Access Compliance Report

Public Rights-of-Way

(Curb Ramps)

Intersection ID: 18381	Main Street: BATHURST_DR	Cross Street: WYALONG_DR	Location: NW
ADA ID: A3A43FF2E359	Ramp Type: Perp	Initial Pass/Fail: Fail	Overall Compliance: No
Codes/Mitigation Info/Possible Solution		Field Measurements/Component Compliance	
Severity Score: 12.5

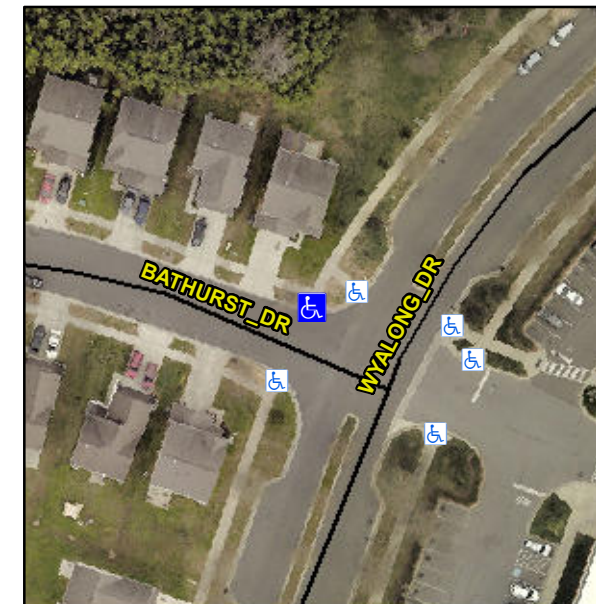
R304.2.2

Compliance	Description	Data	Compliance	Description	Data
N/A	Ramp Length (in)	83.0	No	Ramp Slope (%)	8.8
Yes	Ramp Width (in)	71.0	Yes	Ramp XSlope (%)	0.7
N/A	Flare Type LT	N/A	N/A	Flare Type RT	N/A
N/A	Flare Slope LT (%)	N/A	N/A	Flare Slope RT (%)	N/A
N/A	Flare Traversable LT?	N/A	N/A	Flare Traversable RT?	N/A
N/A	Landing Length (in)	N/A	N/A	DWS Provided?	N/A
N/A	Landing Width (in)	N/A	N/A	DWS Contrast?	N/A
N/A	Landing Slope (%)	N/A	N/A	DWS Length (in)	N/A
N/A	Landing X Slope (%)	N/A	N/A	DWS Full Width?	N/A
N/A	Landing Curb? (Y/N)	N/A	N/A	DWS Offset (in)	N/A
N/A	Shared Landing?	N/A			
N/A	Gutter Ponding?	Yes	N/A	Gutter Slope (%)	N/A
N/A	Gutter Lip Ht (in)	N/A	N/A	Gutter X Slope (%)	N/A
N/A	Painted X Walk1?	No	N/A	Painted X Walk2?	N/A
	X Walk 1 Direction	To SW		X Walk 2 Direction	N/A
N/A	X Walk 1 Width (in)	N/A	N/A	X Walk 2 Width (in)	N/A
	X Walk 1 Slope (%)	1.6		X Walk 2 Slope (%)	N/A
	X Walk 1 X Slope (%)	3.4		X Walk 2 X Slope (%)	N/A

Remove & Replace Entire Ramp.
